1984 - 1985 Corvette: Service Bulletin: Door Ajar Switch Corrosion

Bulletin Number: 85-43, Number 8B (XII) & 10(I)

Date: Feb., 1985

- REPLACEMENT 14087681 DOOR AJAR SWITCH
(WITH SLEEVE)

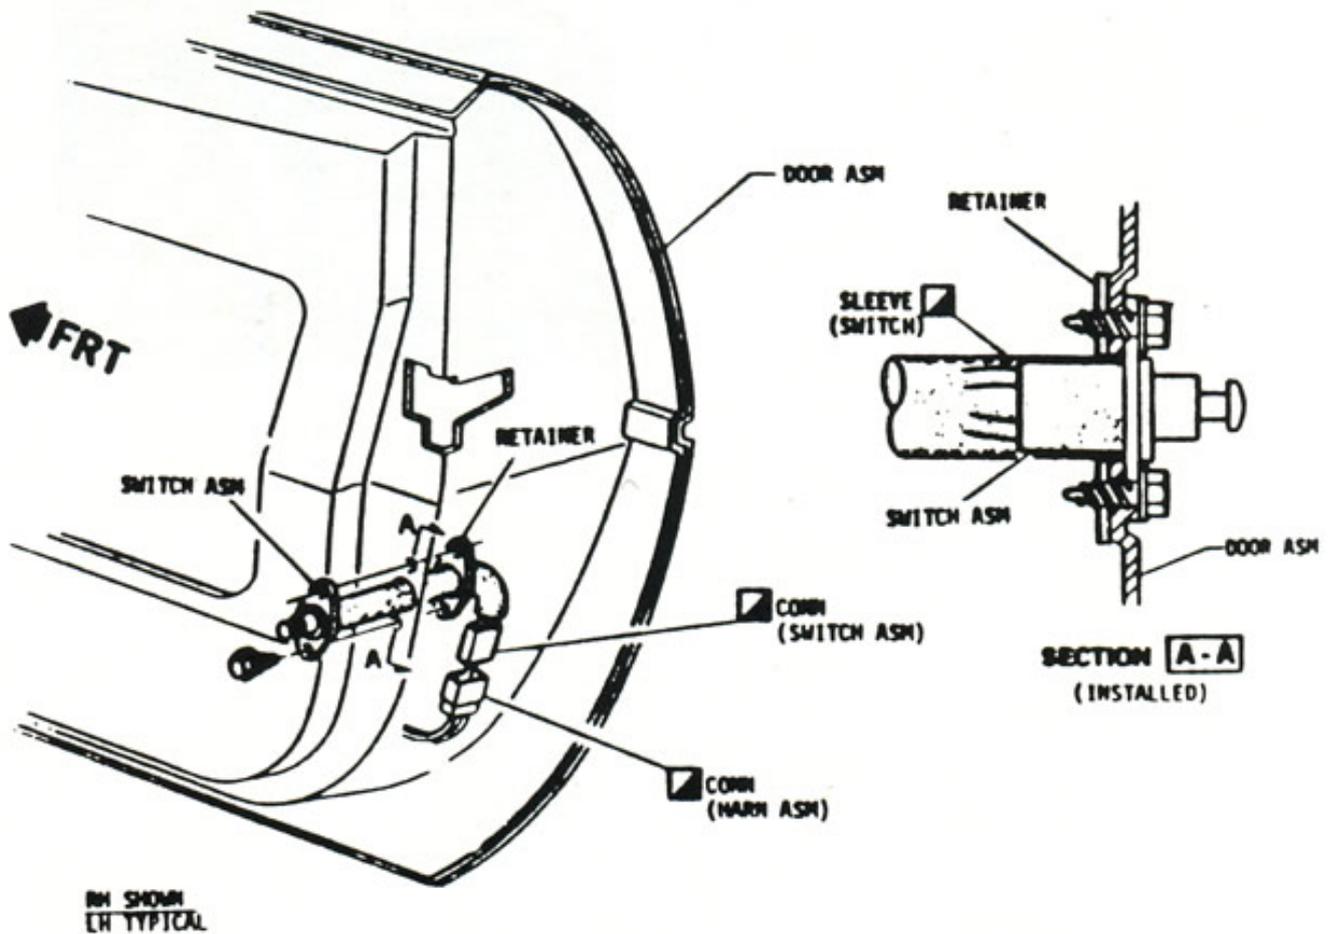
SOME 1984 AND EARLY PRODUCTION 1985 CORVETTE DOOR AJAR SWITCHES (P/N 14062556) MAY BECOME INOPERATIVE DUE TO INTERNAL CORROSION. THIS CAUSES THE DOOR AJAR LIGHT TO EITHER BECOME INOPERATIVE, FLICKER, OR STAY ON.

A NEW CORROSION RESISTANT SWITCH (P/N 14087681) AND AN ASSOCIATED RETAINER (P/N 14087682) ARE TO BE USED AS SERVICE REPLACEMENTS. THE NEW SWITCH INCLUDES A SLEEVE (SEE ILLUSTRATION) THAT FITS TIGHTLY AROUND THE SWITCH'S HOUSING AND HAS SUFFICIENT LENGTH TO COVER THE WIRE CONNECTOR ONCE CONNECTION TO THE DOOR HARNESS IS MADE.

WHEN REPLACING THE EXISTING SWITCH WITH A NEW 14087681 SWITCH, THE DOOR INSERT HOLE WILL NEED TO BE ENLARGED FROM 16MM TO 18MM TO ACCOMMODATE THE SLEEVE PROVISION. CARE MUST BE EXERCISED WHEN ENLARGING THE INSERT HOLE SO THAT ADJOINING MOUNTING HOLES ARE NOT ALTERED. SCRATCHES, CHIPS, ETC., TO DOOR PANEL SURFACE RESULTING FROM THE HOLE ENLARGING PROCESS ARE TO BE COSMETICALLY REPAIRED AS OUTLINED IN SECTION 10 (BODY) OF THE CORVETTE SHOP MANUAL.
